GLEN AT WIDEFIELD FILING NO. 9
SPRING GLEN DRIVE (Sta. 30+00 to Sta. 43+00)
PLAN AND PROFILE
EL PASO COUNTY, COLORADO

Project No.:	17038
Date:	September 25, 2018
Design:	AWMc
Drawn:	JAK
Check:	AWMc
Revisions:	
	Δ 4/16/19 Profile/San. Sewer

**GLEN AT WIDEFIELD FILING NO. 9
BITTERCRESS PLACE (Sta. 0+00 to Sta. 9+00)
PLAN AND PROFILE
EL PASO COUNTY, COLORADO**

CUL-DE-SAC PROFILE

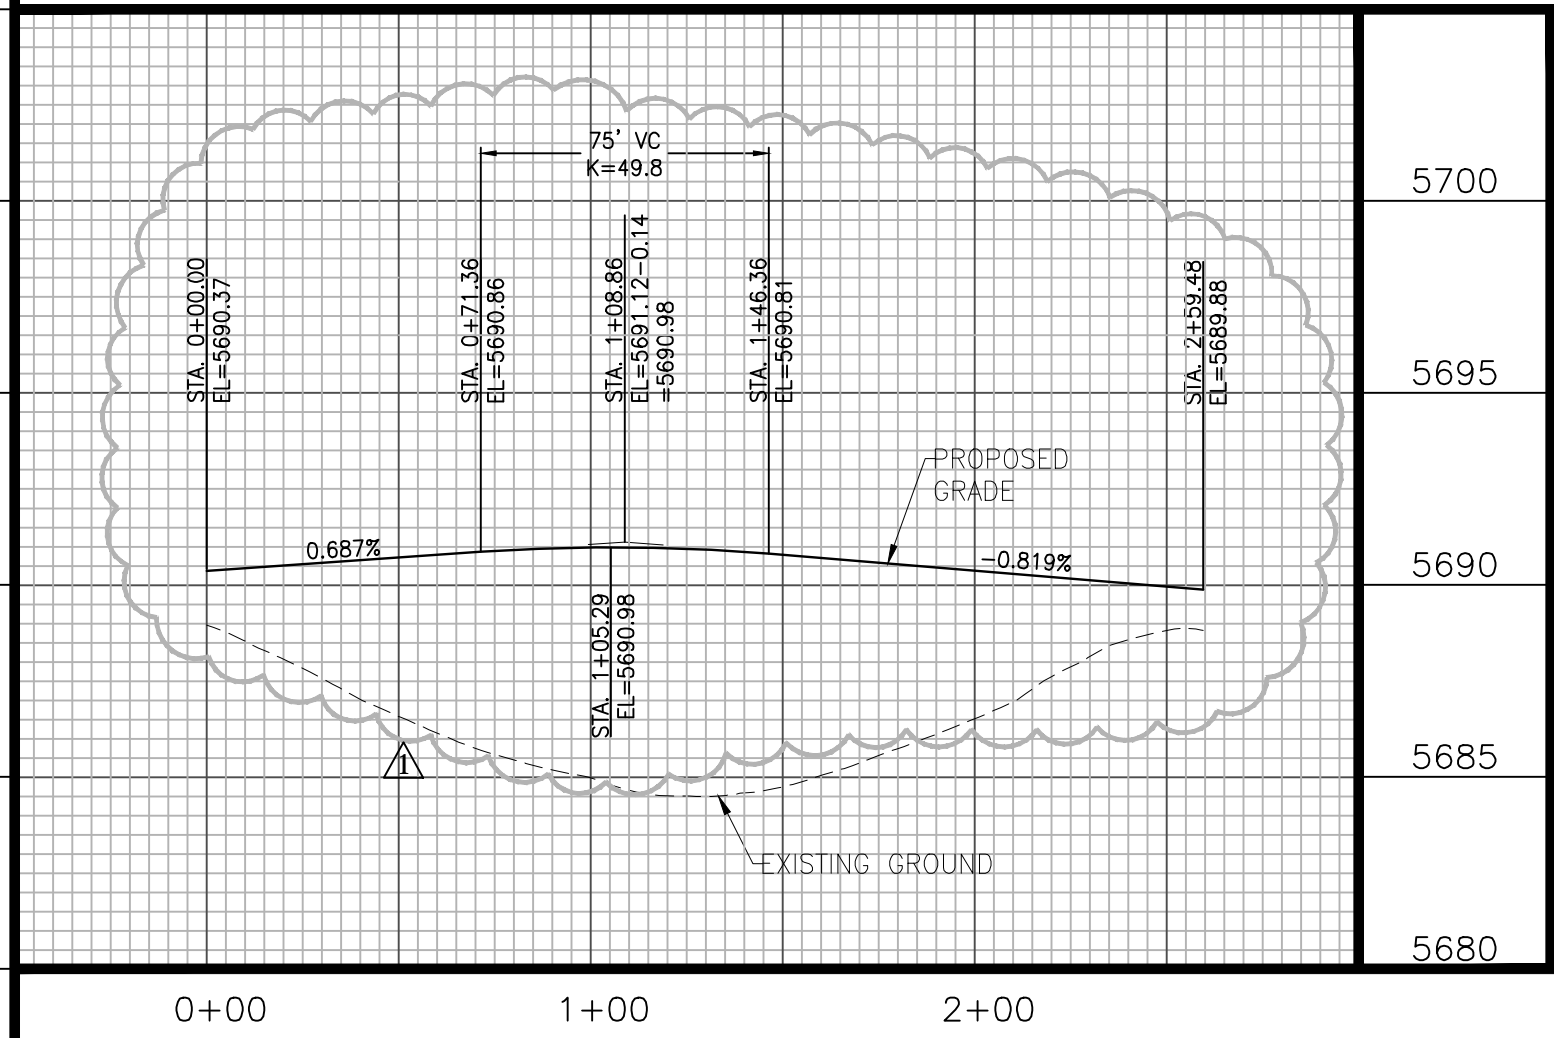
Adjust. Min Ksag = 26

**GLEN AT WIDEFIELD FILING NO. 9
BITTERCRESS PLACE (Sta. 9+00 to Sta. 14+39)
PLAN AND PROFILE
EL PASO COUNTY, COLORADO**

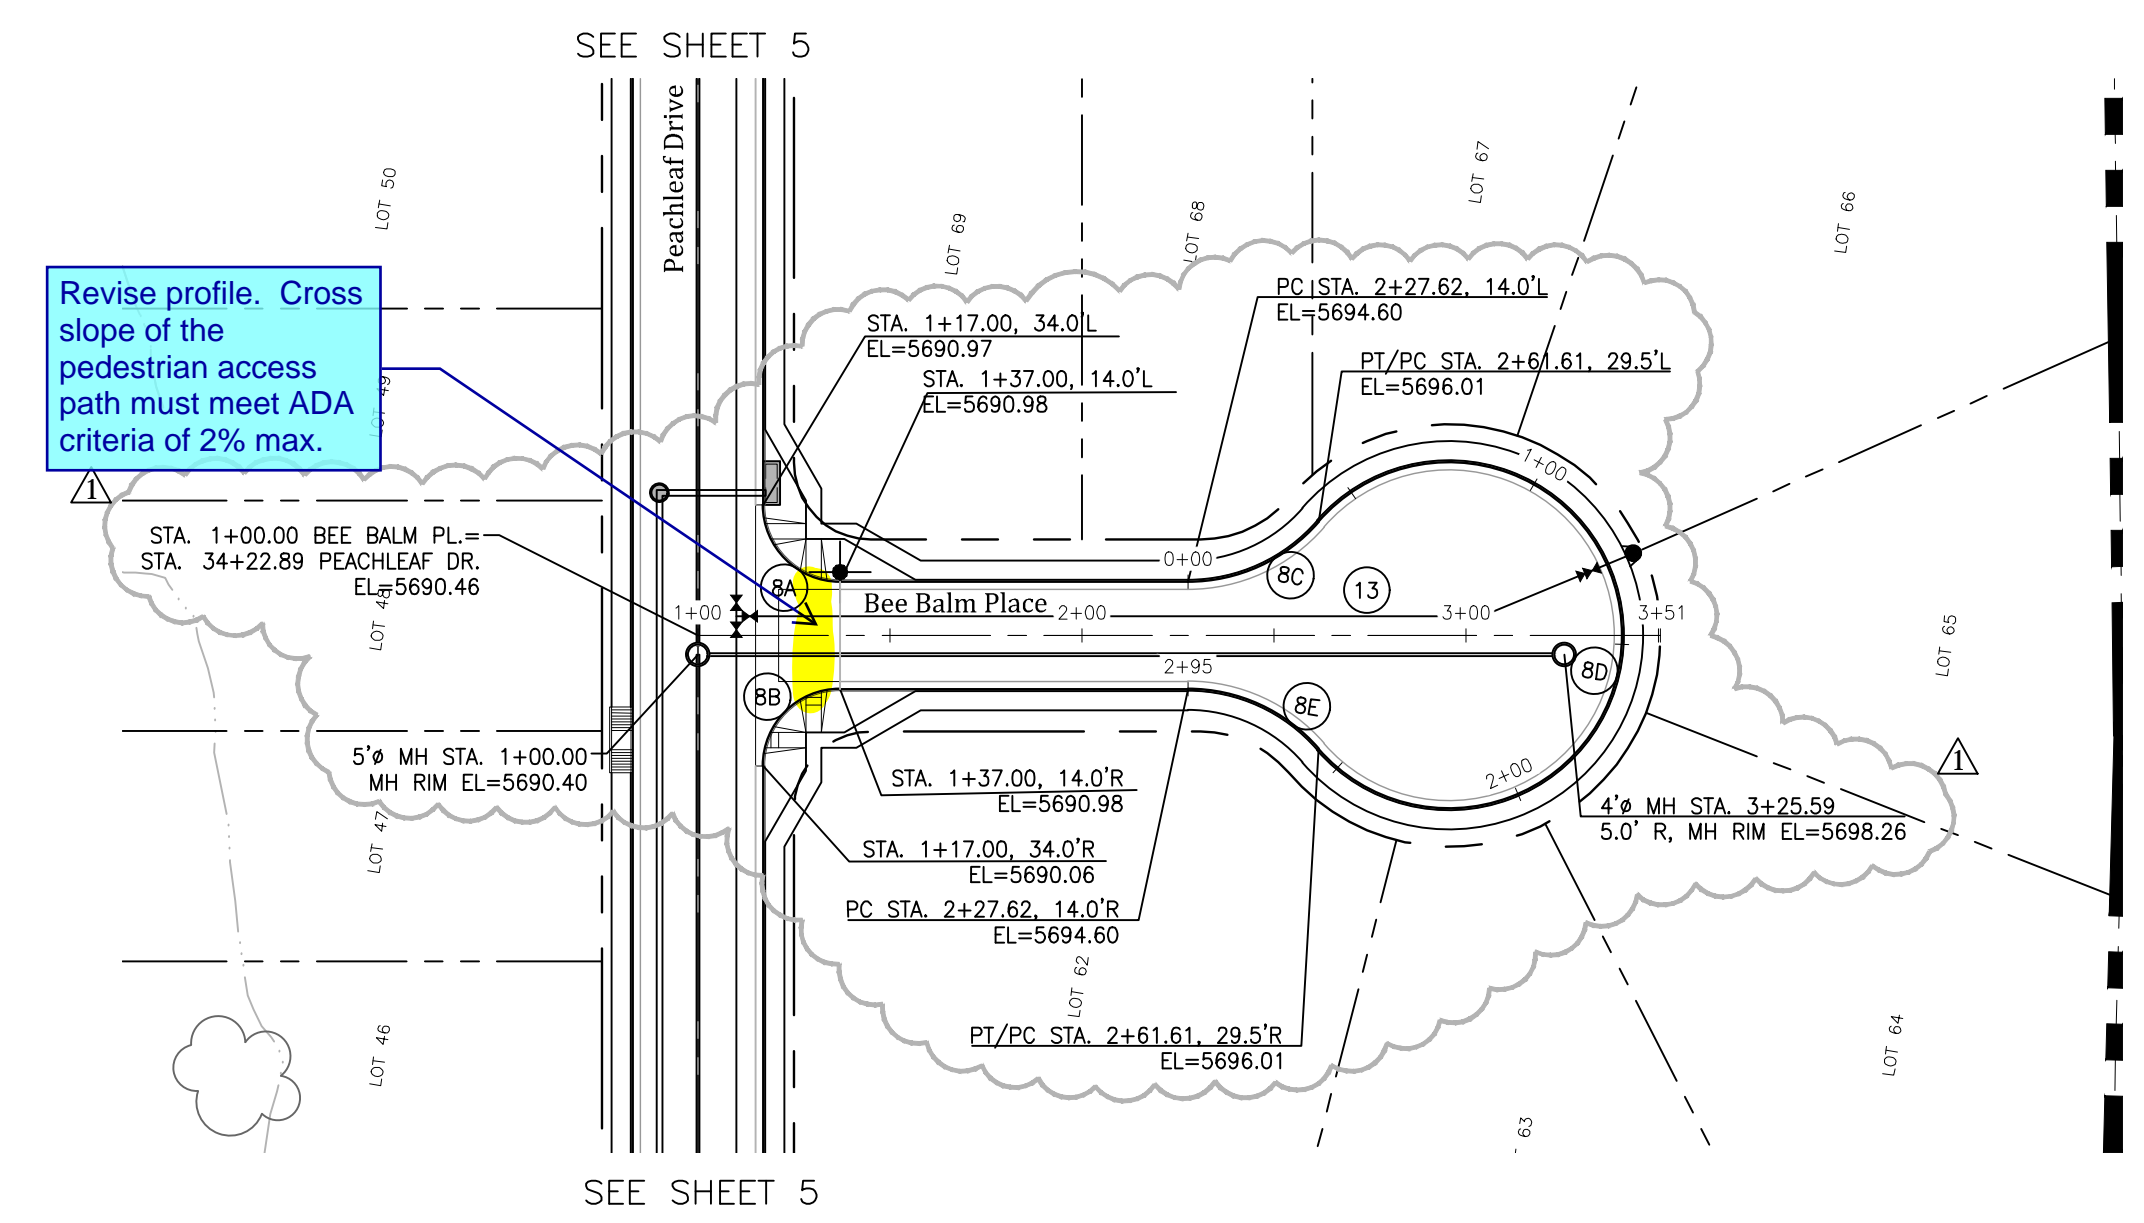
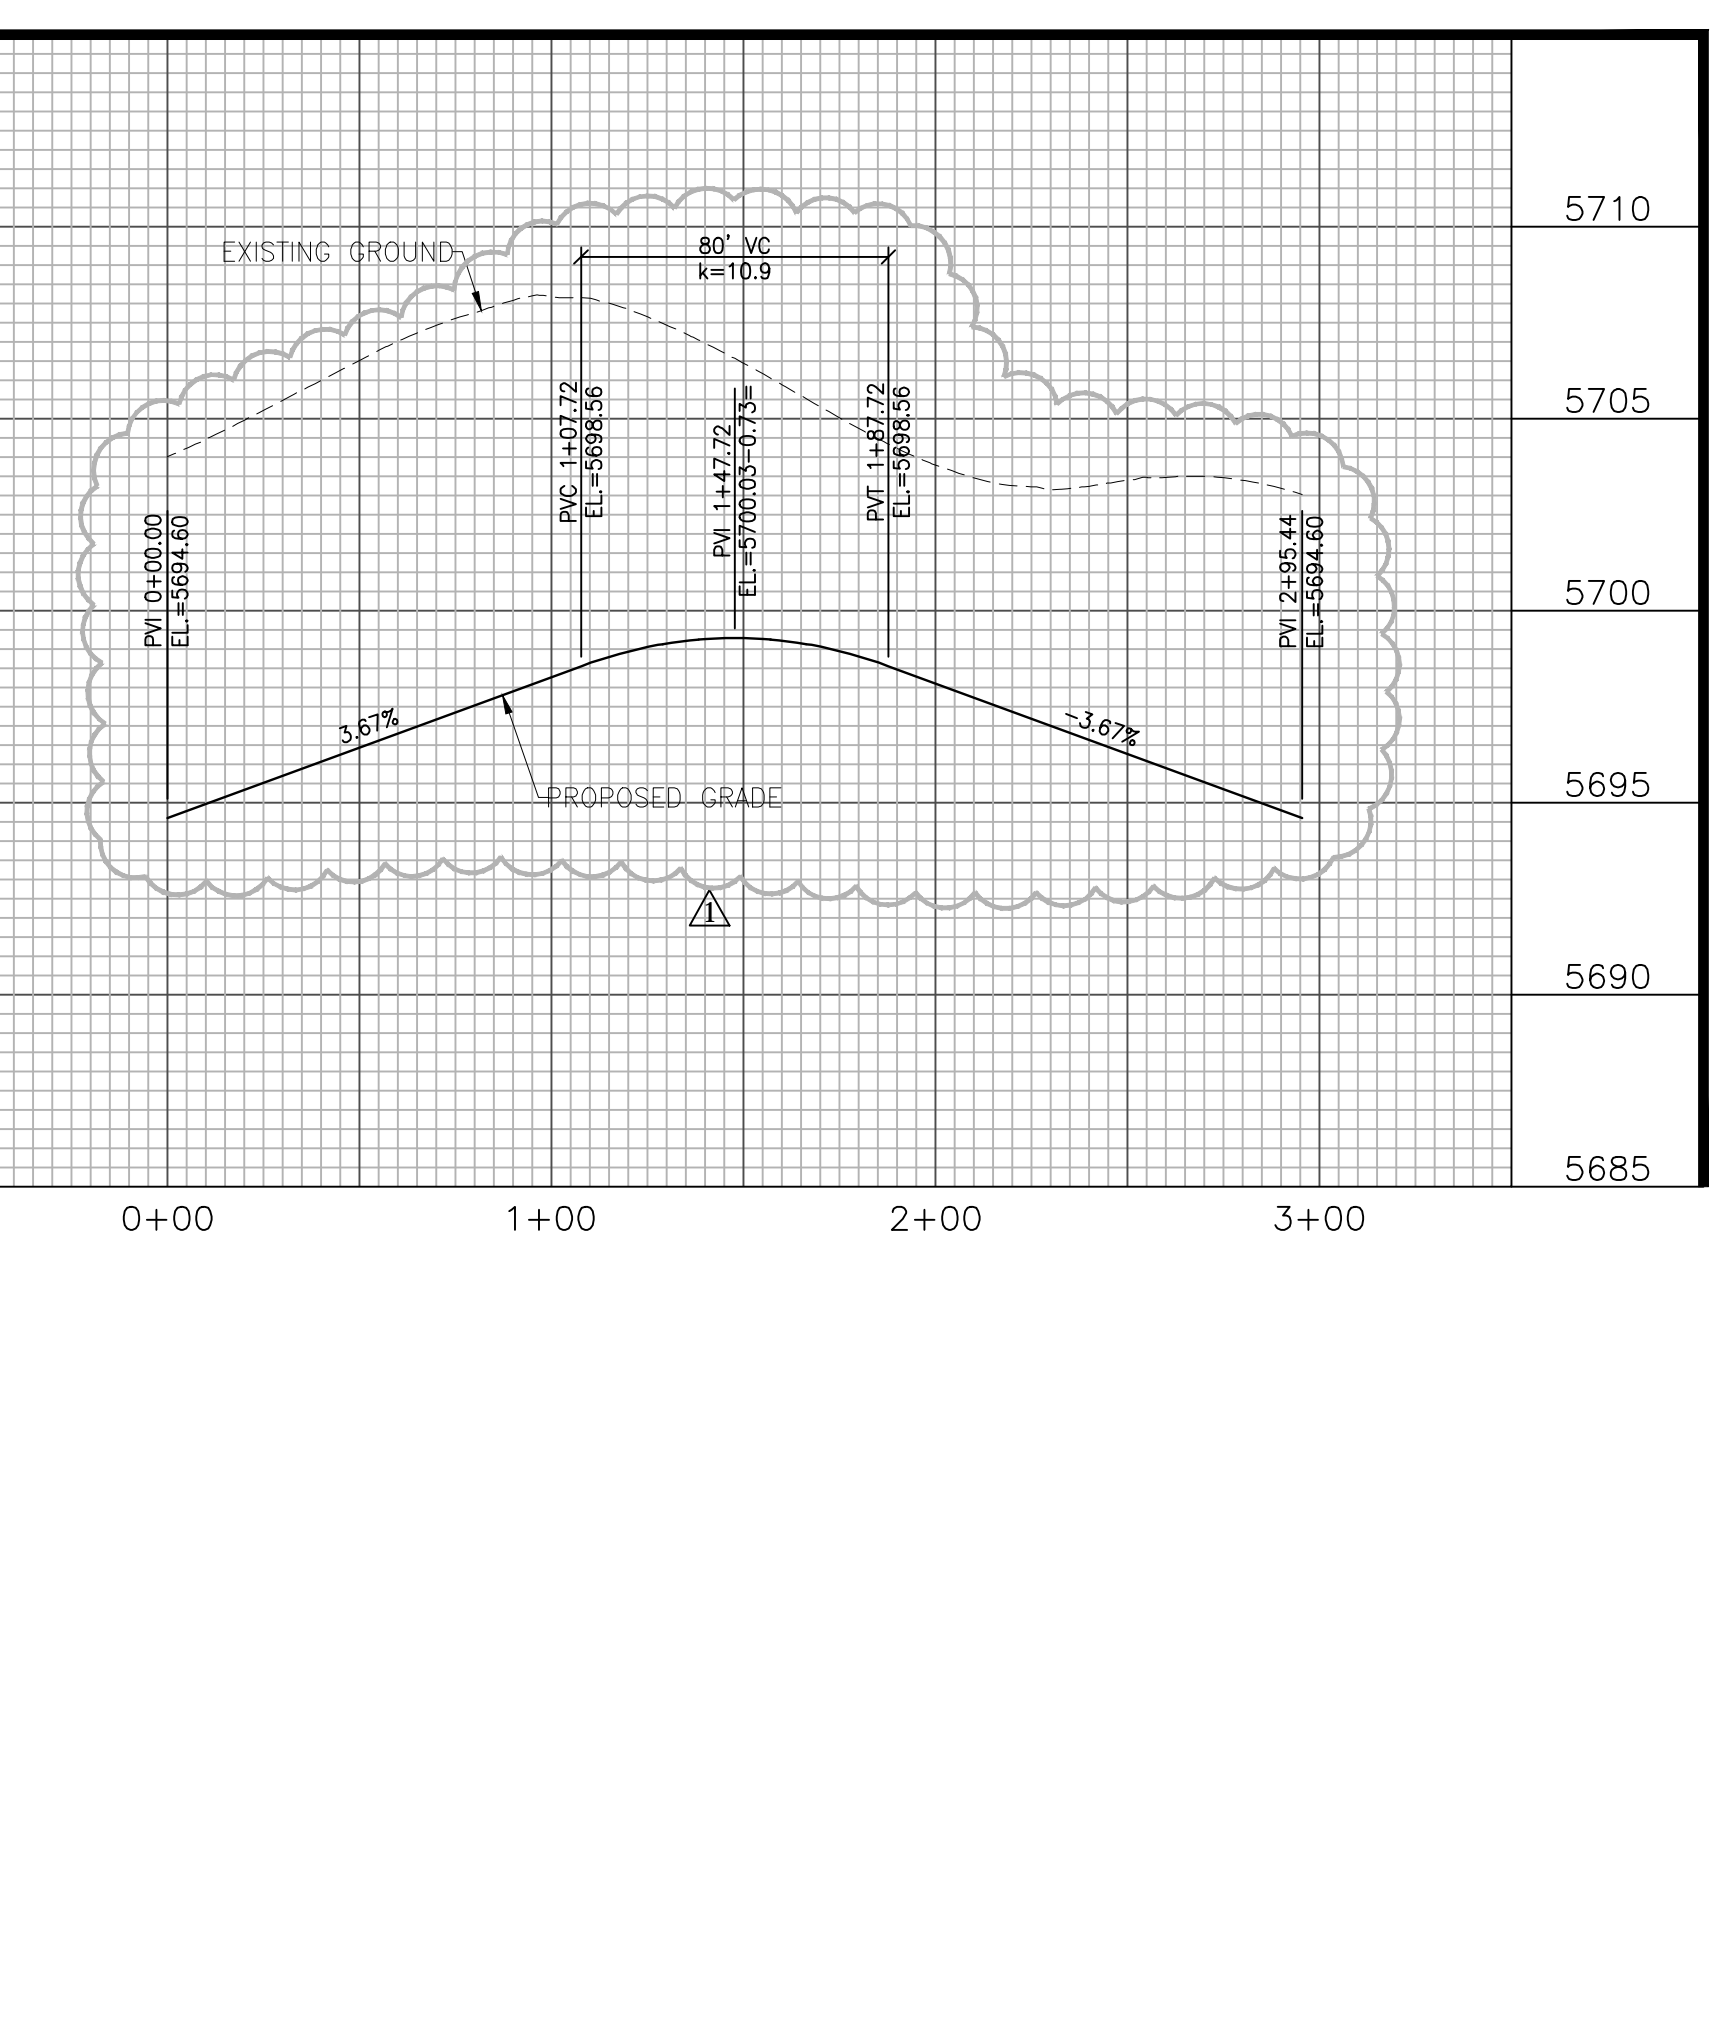
Revise profile. Cross slope of the pedestrian access path must meet ADA criteria of 2% max.

Revise centerline profile grade within the cul-de-sac bulb to 3.0% max. See ECM Section 2.3.8 Figure 2-31.
